J2127A-04A

S E R V I C E N O T E

J2127A AGILENT Transmission Test Set

Problems with ESD clips on the Clock and Electrical/Digital boards

Figure 1 Location of ESD Clips

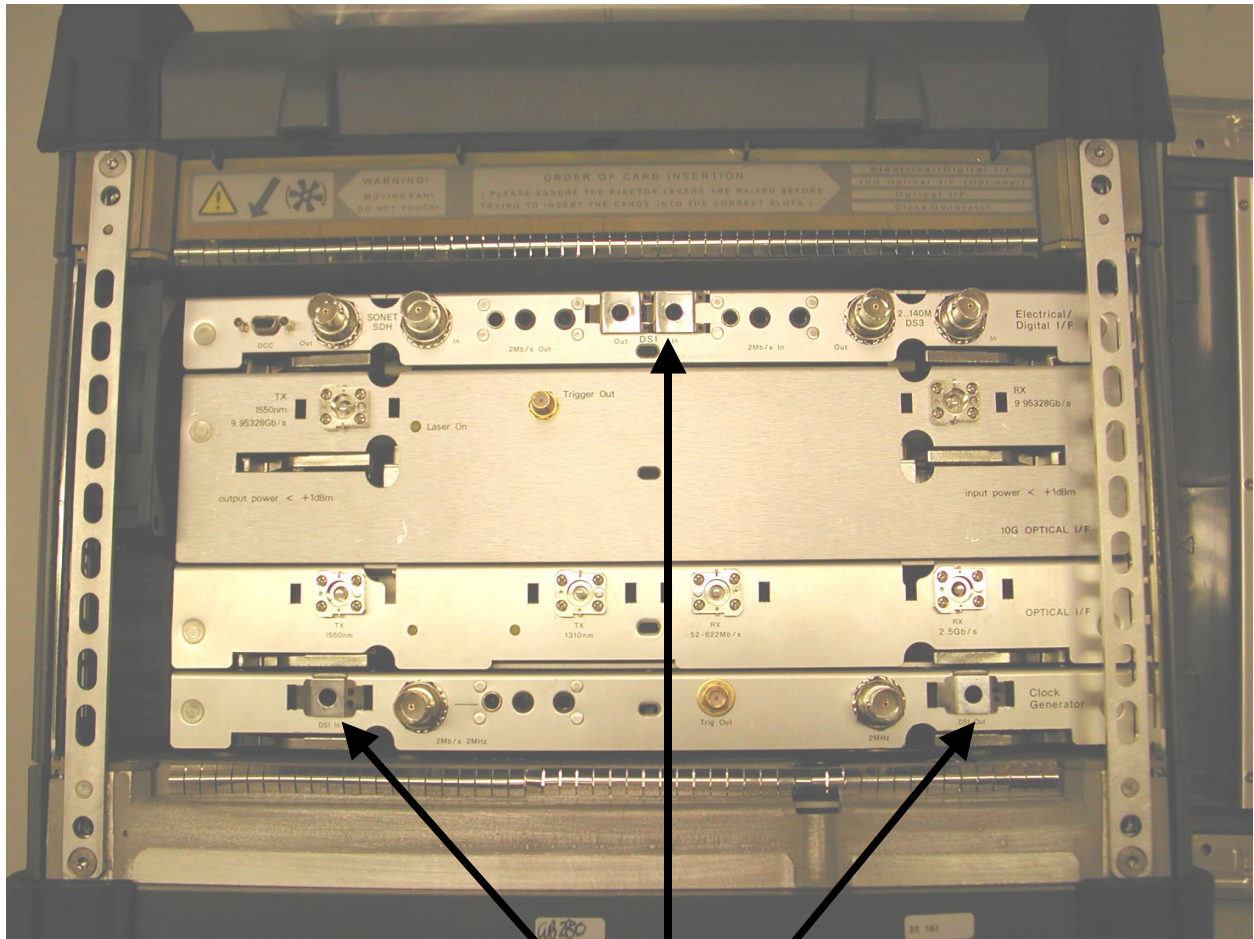
On early shipments of units we have experienced some problems when inserting or removing a bantam cable connector to the DS-1 ports on the Clock board and the Electrical/Digital board. The DS1 port on the boards are fitted with ESD clips and some instruments may be fitted with the wrong size clips. This causes the cable connector to scrape against the clips, leading to small metal scrapings falling into the instrument.

Please check units within the serial breakpoint as follows. Insert and then remove a DS1 bantam cable into all DS1 ports. If the cable moves in and out smoothly, there is no problem with the clips. However, if the cable requires pressure to be inserted or removed, the clips should be inspected and changed if necessary.

1. Unscrew the torque #15 screws at each corner of the top panel.
2. Remove the top panel.
3. Check that the ESD clips are properly aligned with the holes on the board panels.
4. Insert and remove the DS1 bantam cable into all of the ESD clips.
5. If the cable moves in and out smoothly, replace the top cover and retry.
6. If the cable still requires pressure to insert and remove, replace the clips using a suitable tool such as tweasers.

Note 1: To remove the clips, lever out one side first and then the other. To fit a new clip, fit one side of the clip first and then the other.

Note 2: When the clips are being replaced, the boards should be removed and the inside of the instrument inspected for any small pieces of metal scrapings. These should be removed before refitting the boards.
